Ernest J. Harkness
Vice President440-280-5382
Fax: 440-280-8029June 23, 2014
L-14-150

Perry Nuclear Power Plant
Docket No. 50-440, License No. NPF-58
Request for Licensing Action to Amend Technical Specification 3.4.11, "RCS Pressure and Temperature (P/T) Limits"

Subject: Request for Licensing Action to Amend Technical Specification 3.4.11, "RCS Pressure and Temperature (P/T) Limits."

Figure 3.4.11-1(f): Core Critical Operation (Curve C) (Valid Up to 32 EFPY – Unit 1)

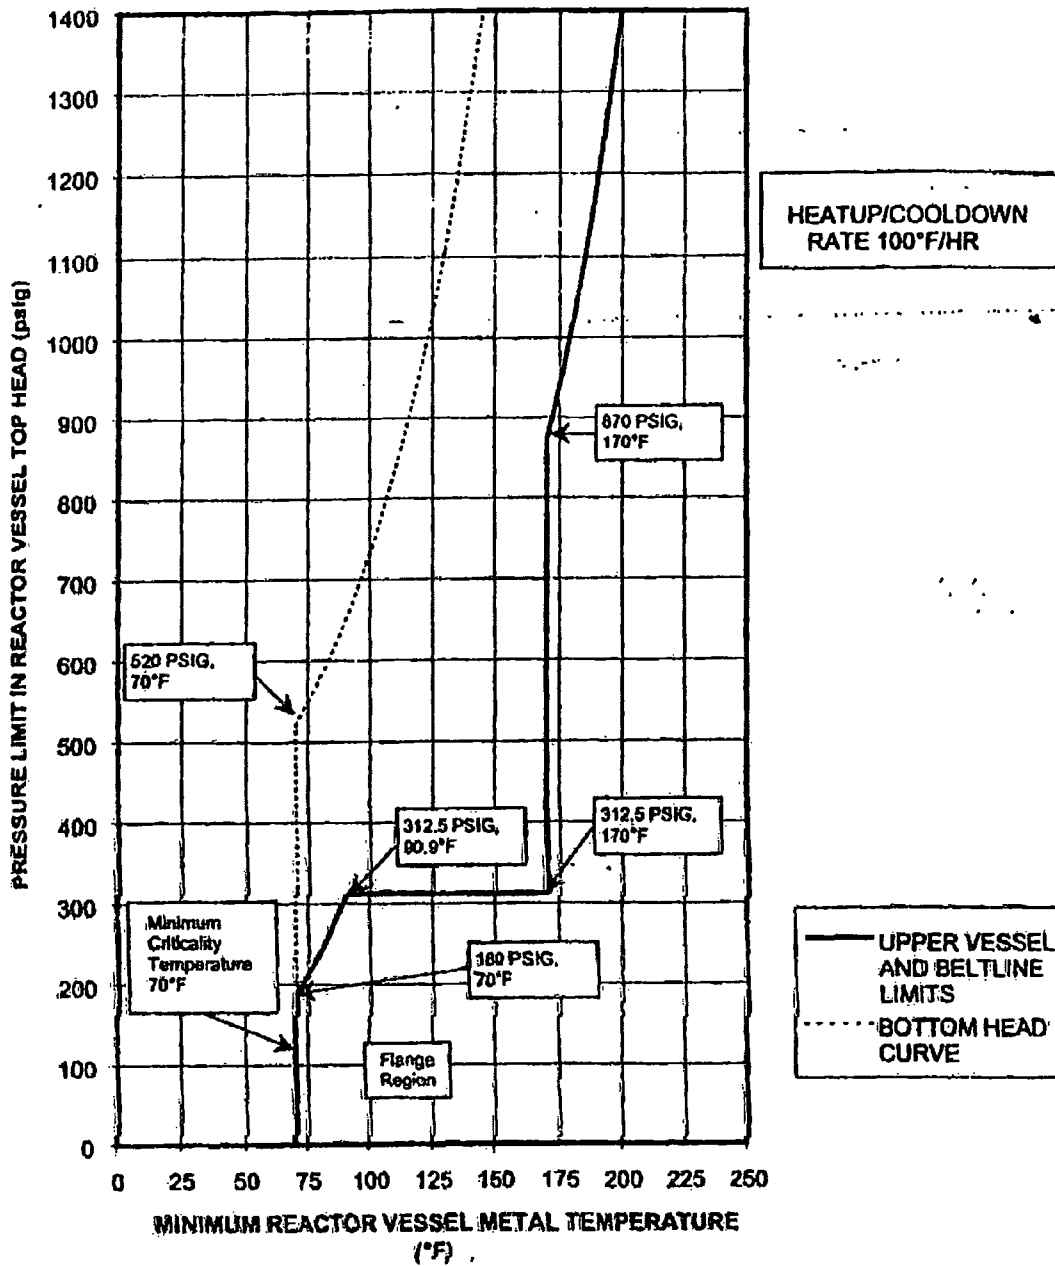
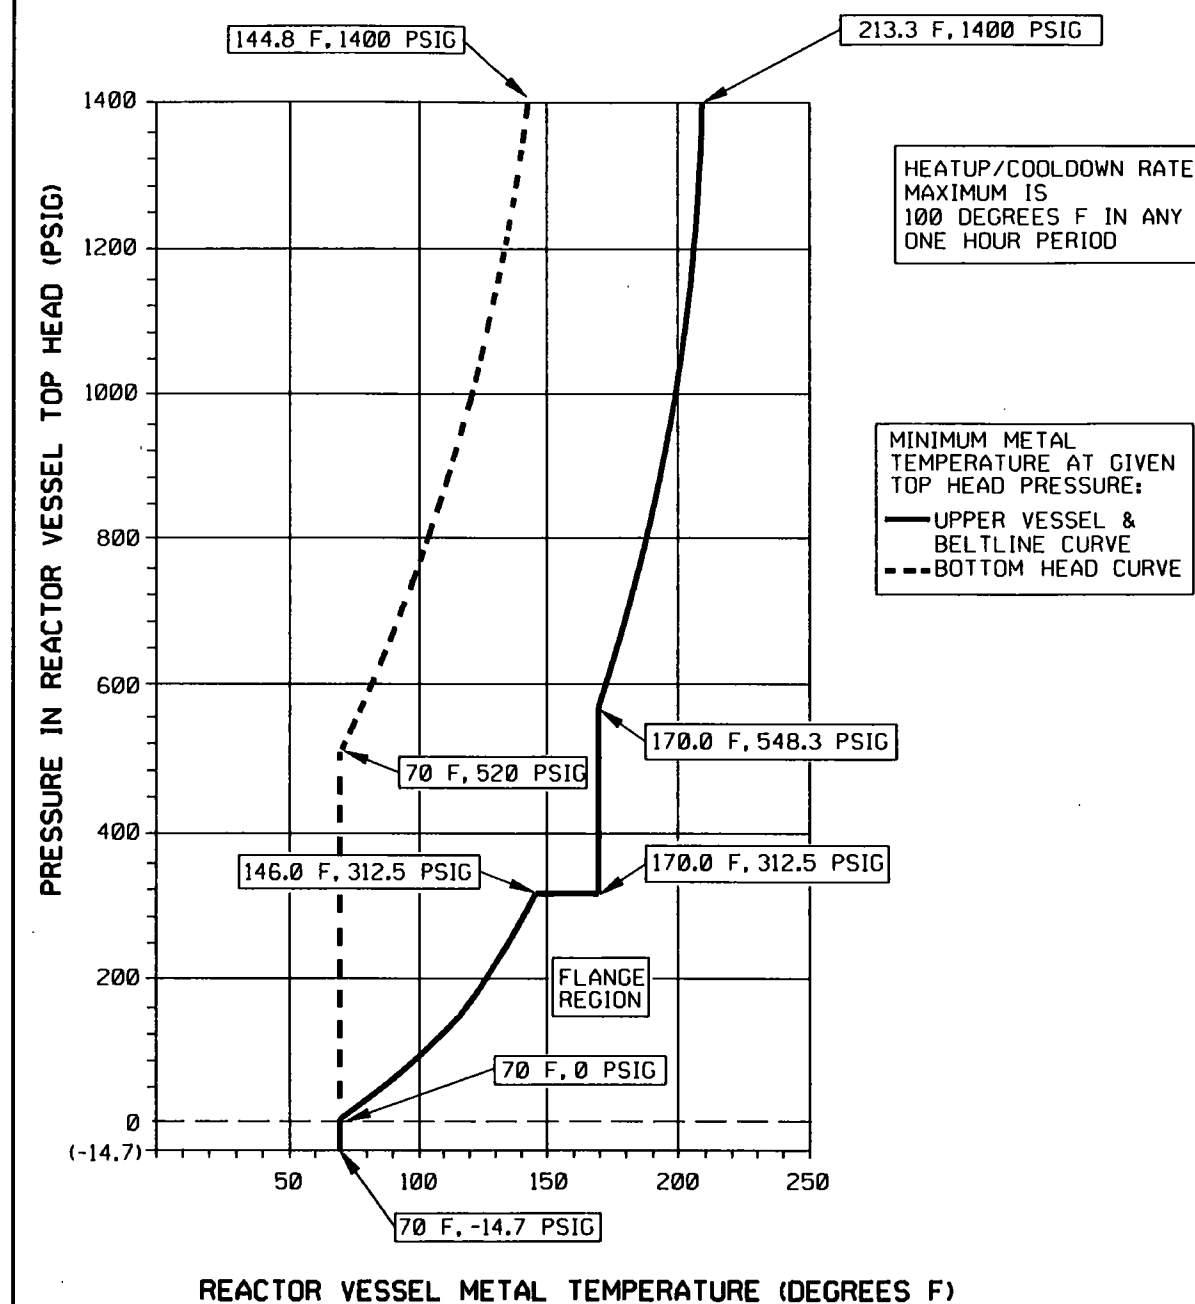
Figure 3.4.11-1(f): Core Critical Operation (Curve C) (Valid up to 32 EFPY – Unit 1)

This figure will be updated and retitled as Figure 3.4.11-1(c): Core Critical Operation Curves (Valid up to 32 EFPY). The words “Curve C” and “Unit 1” were dropped from the title; Curve C was a carryover from when one P/T limit figure had multiple curves, and Unit 1 is unnecessary as PNPP is a single unit site. The word “Curves” was added to the title as the figure depicts two curves. The word “Limit” was dropped from the Y axis label; this axis depicts pressure in the reactor vessel top head and the curves depict the actual pressure limits. The word “Minimum” was dropped from the X axis label; this axis depicts reactor vessel metal temperature and the curves depict the actual minimum required temperatures. The word “Maximum” was added to the figure’s note box describing heatup/cooldown rate; this note intended the heatup/cooldown rate to be an “up to a maximum” rate rather than a single specific rate as currently depicted. The clarification words “Minimum metal temperature at given top head pressure” were added to the curve legend box as a result of the editorial changes made to the X and Y axis labels.

With the update described in the technical evaluation below, portions of the upper vessel and beltline P/T limit curve will generally shift downward and to the right, and will extend into the vacuum region with a new endpoint (70 F, -14.7 psig). Both P/T limit curves will now include temperature limits at their existing upper (1400 psig) endpoints.

REMOVE and REPLACE this FIGURE with
the RENAMED and UPDATED FIGURE.

FIGURE 3.4.11-1(c): CORE CRITICAL OPERATION CURVES (VALID UP TO 32 EFY)

Figure 3.4.11-1(a) Pressure Test Curve (Curve A) (Valid Up to 32 EFPY-Unit 1)

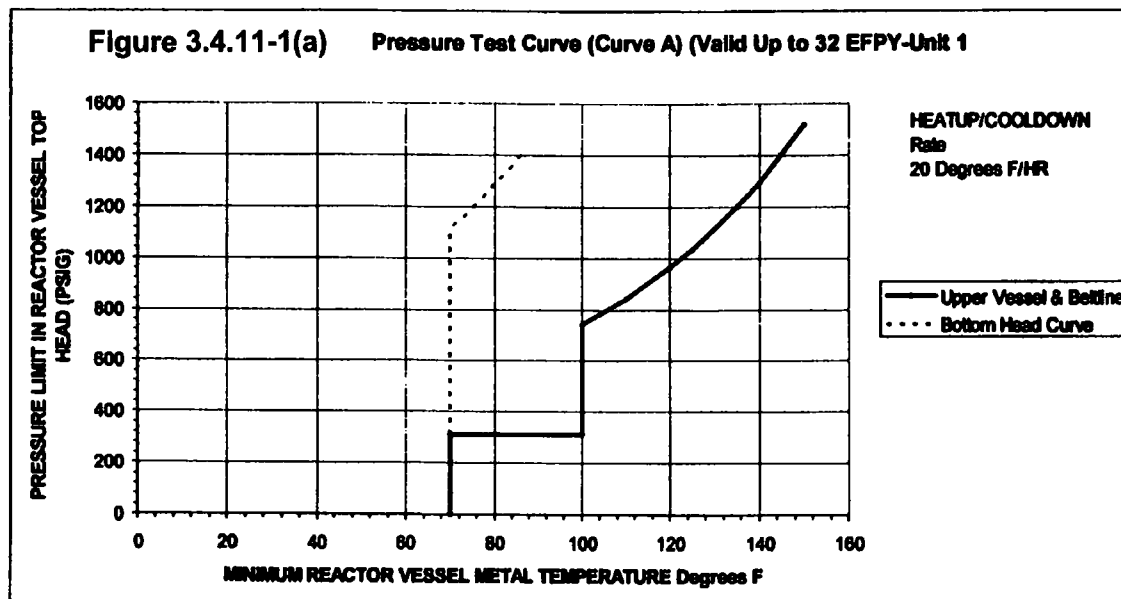
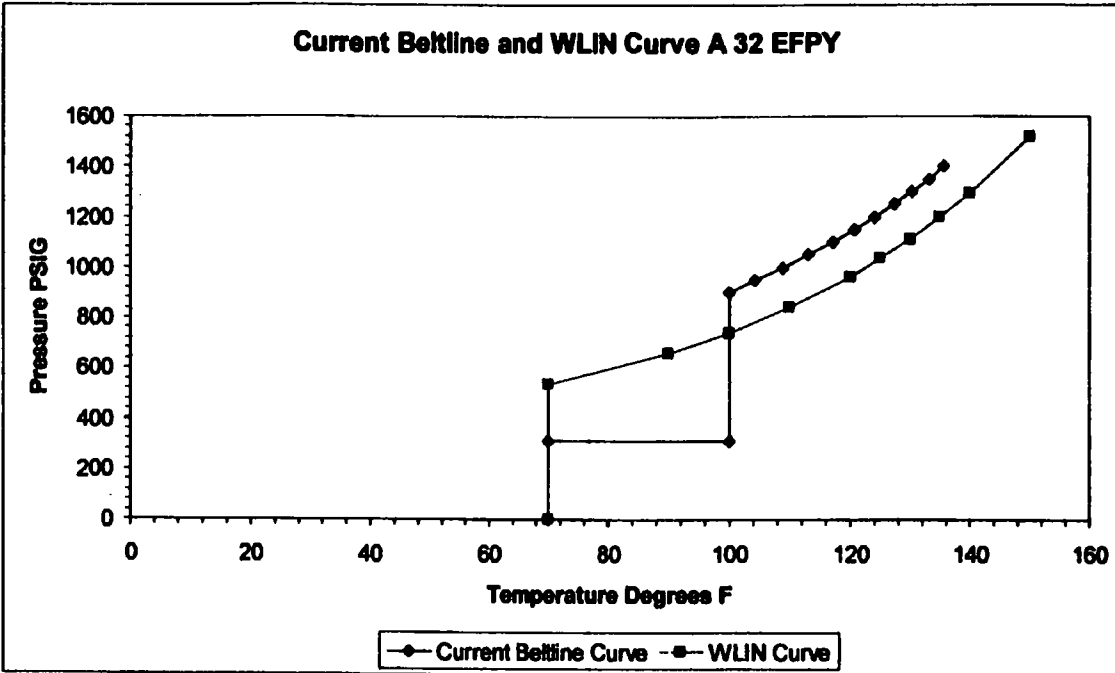
For the 32 EFPY curve the data points are plotted in Attachment 2. Figure 1 of Attachment 2 is the update of TS Figure 3.4.11-1(d) and includes the WLIN results. Figure 2 of Attachment 2 compares the current TS beltline curve to the WLIN beltline curve. The WLIN curve is more conservative (requires higher temperature for same pressure) than the current beltline curve. The WLIN Curve controls pressure above 100 degrees F and 740 psig.

Figure 3.4.11-1(b) Non-Nuclear Heatup/Cooldown (Curve B) (Valid Up to 32 EFPY-Unit 1)

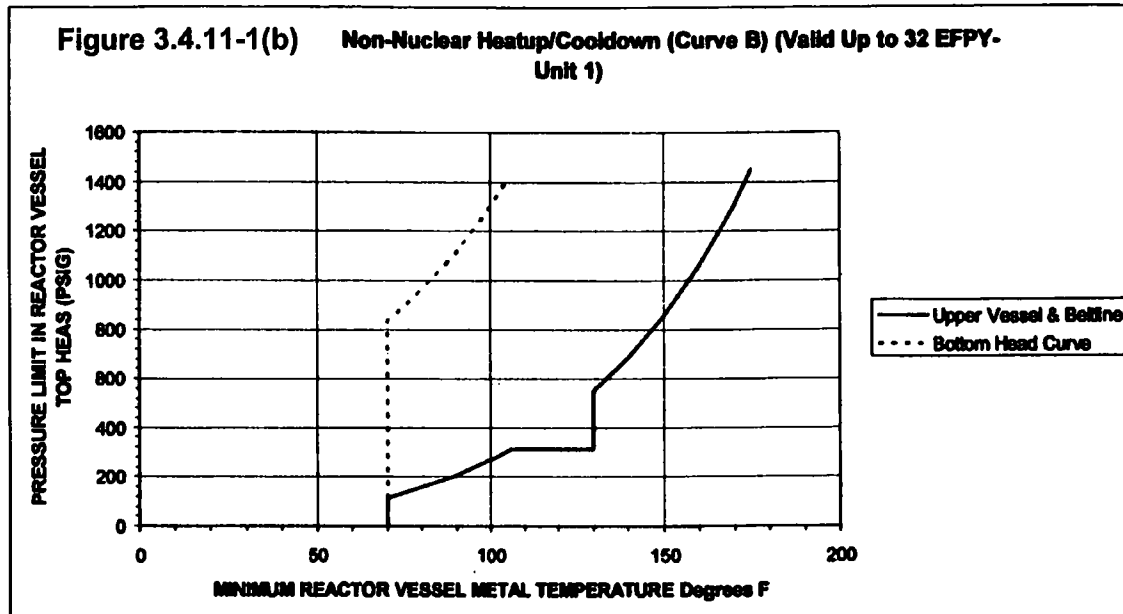
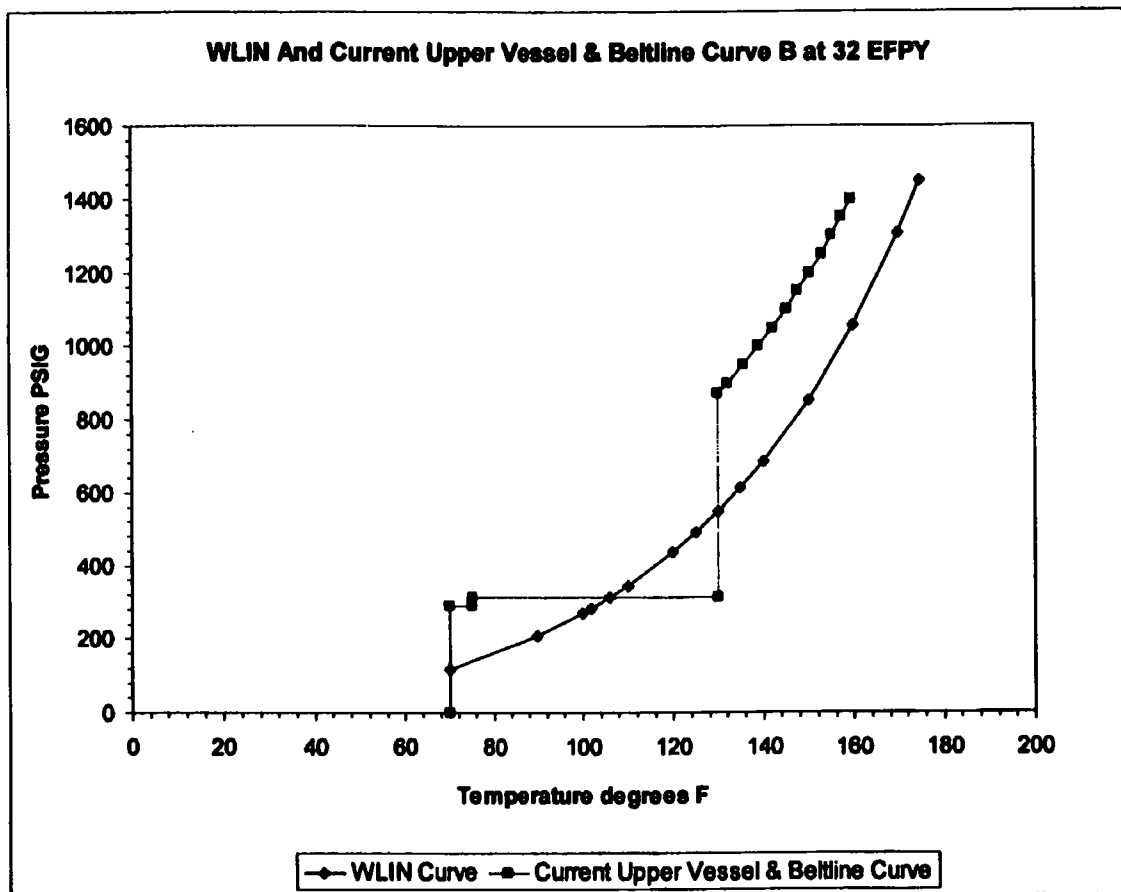
For the 32 EFPY curve the data points are plotted in Attachment 4. Figure 1 of Attachment 4 is the update to TS Figure 3.4.11-1(e) Non-Nuclear Heatup / Cool down (Curve B) (Valid up to 32 EFPY-Unit 1). Figure 2 illustrates the impact of the WLIN curve to control pressure between 70 and approximately 106 degrees and greater than 130 degrees.

Figure 3.4.11-1(c) Core Critical Operation (Curve C) (Valid Up to 32 EFPY-Unit 1)

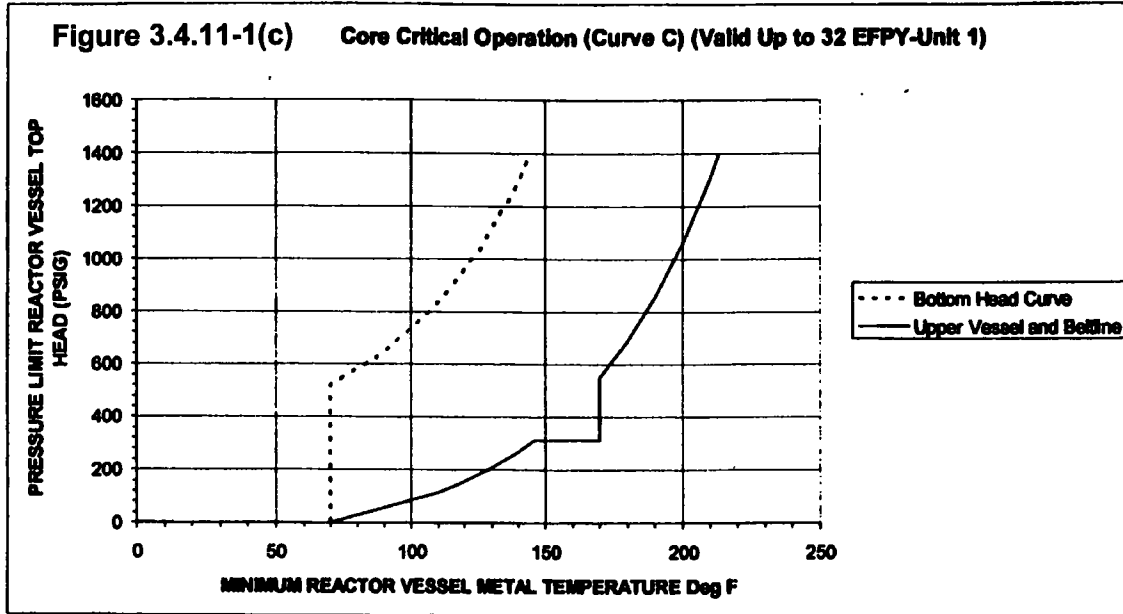
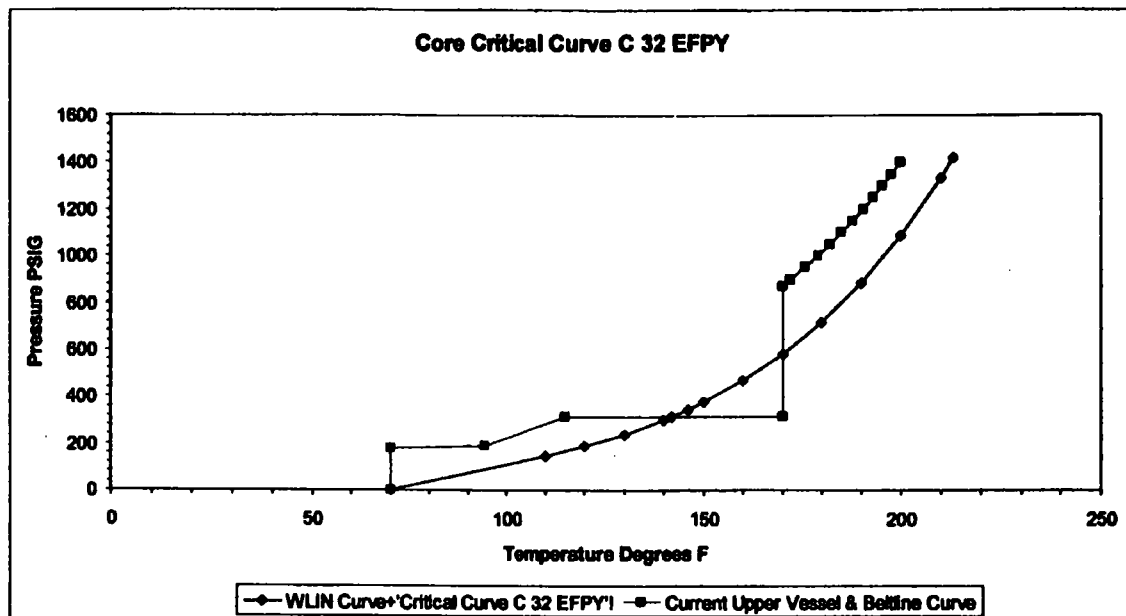
For the 32 EFPY curve the data points are plotted in Attachment 6. Figure 1 of Attachment 6 is the update of TS Figure 3.4.11-1(f) Core Critical Operation (Curve C) (Valid Up to 32 EFPY- Unit 1). The Upper Vessel and Belt line limits are a composite of the 10CFR50 Appendix G minimum temperature requirements and the WLIN impact on the beltline. Figure 2 of
